MEMORANDUM

DATE: April 16, 1968

FOUNDATION INVESTIGATION REPORT
For
Eastbound Lane and Westbound Lane
Structures at the Crossing of
Prop. Hwy. #417 and 7th Line Rev'n.
Twp. of Gloucester, Co. of Carleton
District No. 9 (Ottawa)
W.J. 67-F-113 -- W.P. 34-66-07

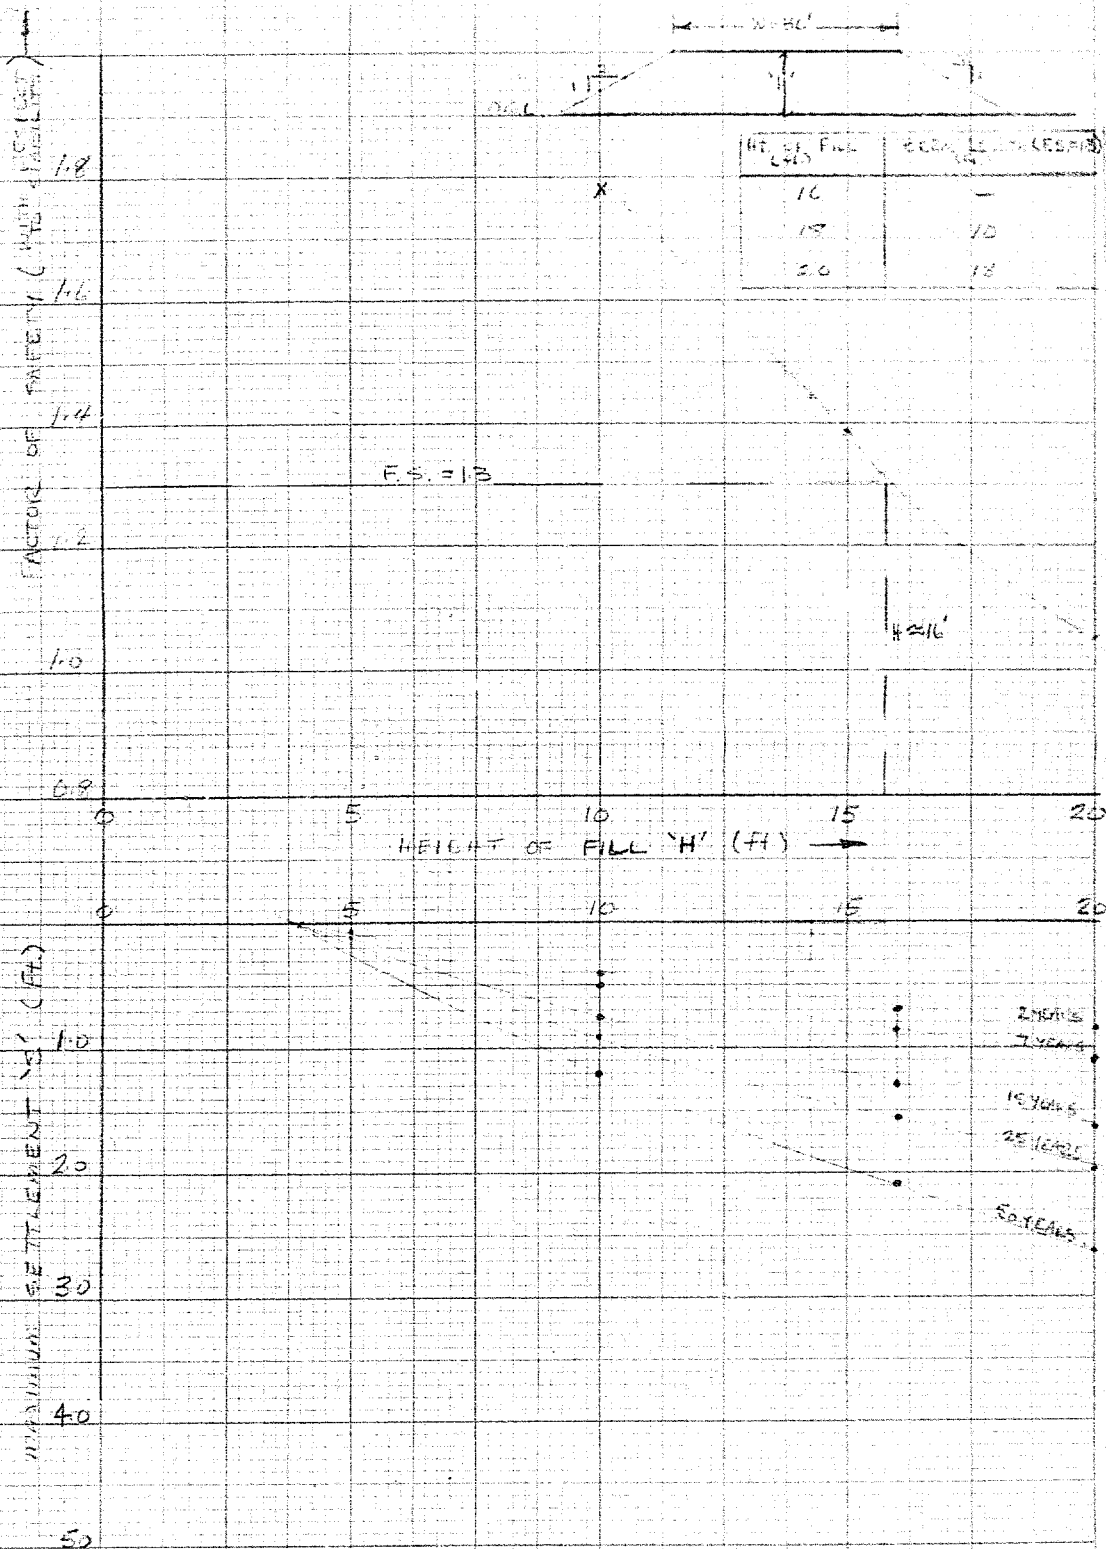
We have reviewed the Preliminary Drawing D-6486-P1 for the above mentioned project and submit the following comments:
